## Assessing new nuclear power station designs

Generic design assessment of Hitachi-GE's Advanced Boiling Water Reactor

Assessment report - AR03 Best available techniques

December 2017

**Figure 1: Diagrammatic representation of gaseous, liquid and solid waste arisings within the UK ABWR (Hitachi-GE, 2017c).**

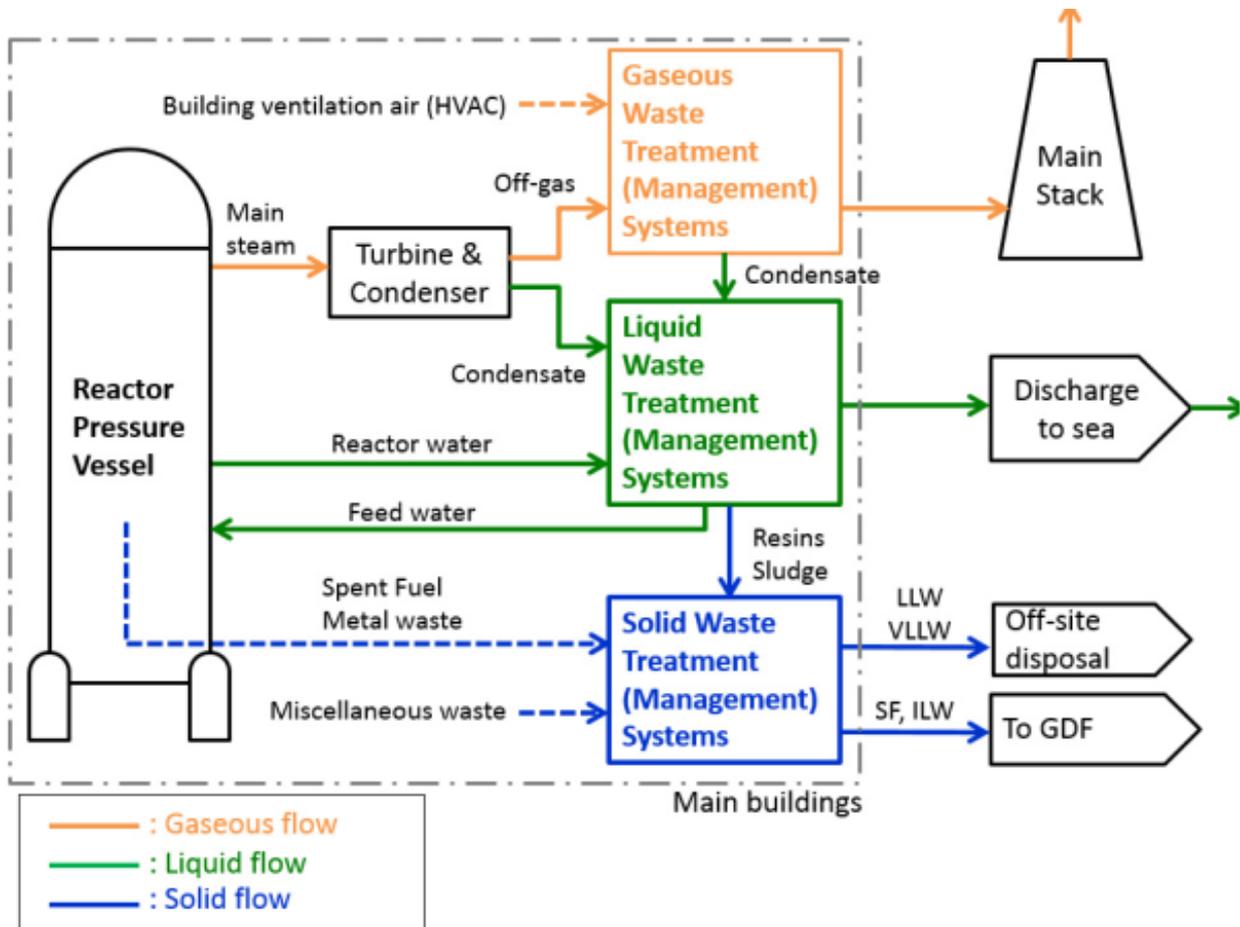
Steam used in the turbine gland steam system (TGS) is derived from the condensate system and is one source of tritium discharge (see discussion of Argument 2e, below). This source is not shown in Figure 1. We raised a RO regarding discharges from the turbine gland steam system (RO-ABWR-0071, 'Turbine Gland Steam System: Discharges and Optimisation') and this has now been closed to our satisfaction (Hitachi-GE, 2016c).

The HVAC system is identified as 'building ventilation air' in Figure 1. The functions of the HVAC system for managing gaseous radioactive wastes are limiting and containing the possible release of radioactive materials from plant and equipment in a room/area; and, where necessary, filtering contaminated air prior to its discharge into the atmosphere.

The liquid radioactive waste management system (LWMS) (shown in green in Figure 1) is designed to control, collect, segregate, process, handle, store, and dispose of radioactive waste water generated during operation of the UK ABWR reactor and turbine. All potentially radioactive waste waters are collected in sumps or drain tanks at various locations in the plant and transferred to collection tanks within the radioactive waste building.

**Figure 2: Diagrammatic representation of the configuration of the liquid management system (Hitachi-GE, 2017a).**

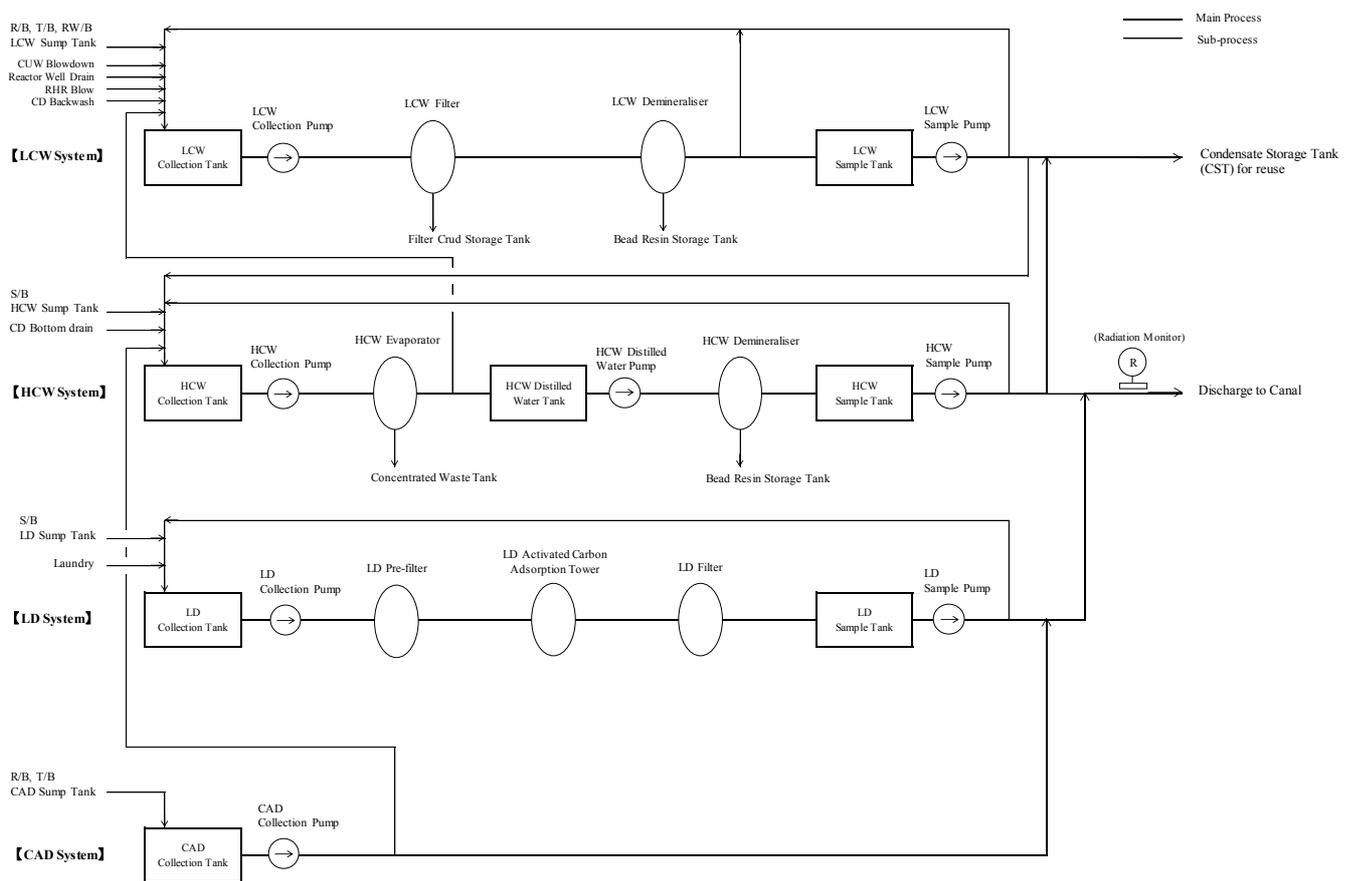
We challenged a potential revised design of the HCW liquid waste management system, which would have resulted in removing the evaporator from the design (RQ-ABWR-0668). Following further consideration, Hitachi-GE opted to reinstate the evaporator.
